ADDENDUM NUMBER 1

MILWAUKEE COUNTY
ZOOLOGICAL GARDENS
PARKING LOT 1 AND WALKWAYS
RE-PAVING & LIGHTING
10001 West Blue Mound Road
Site #355
Milwaukee, WI 53226

Project Number: Z083-11631
Notice Number: 6872

Date of Addendum: December 5, 2013

SKT002

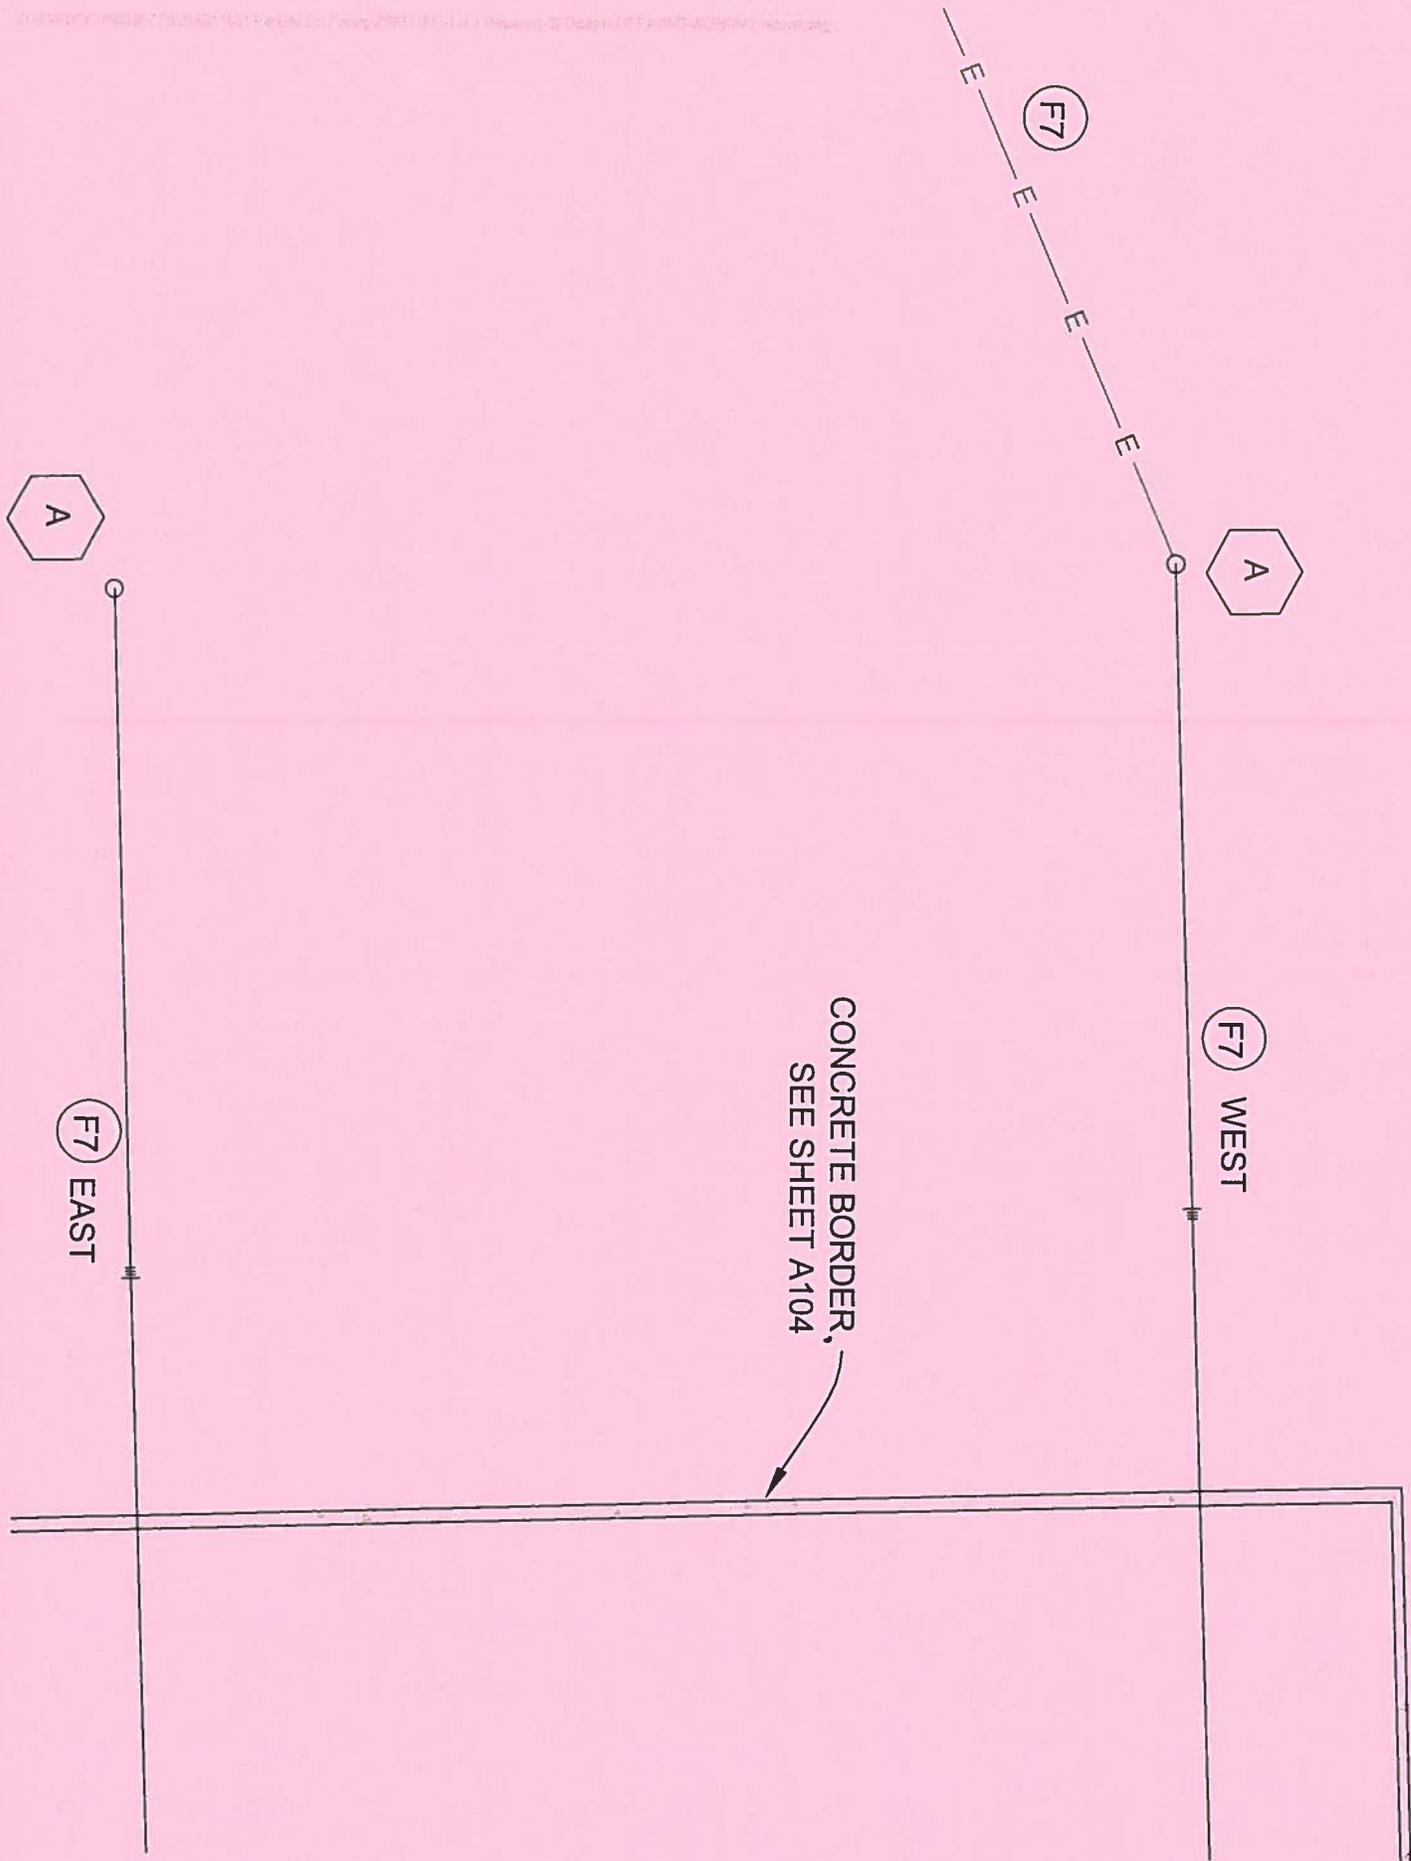
9) Add note as shown in SKT 002 to identify concrete border at permeable pavers.
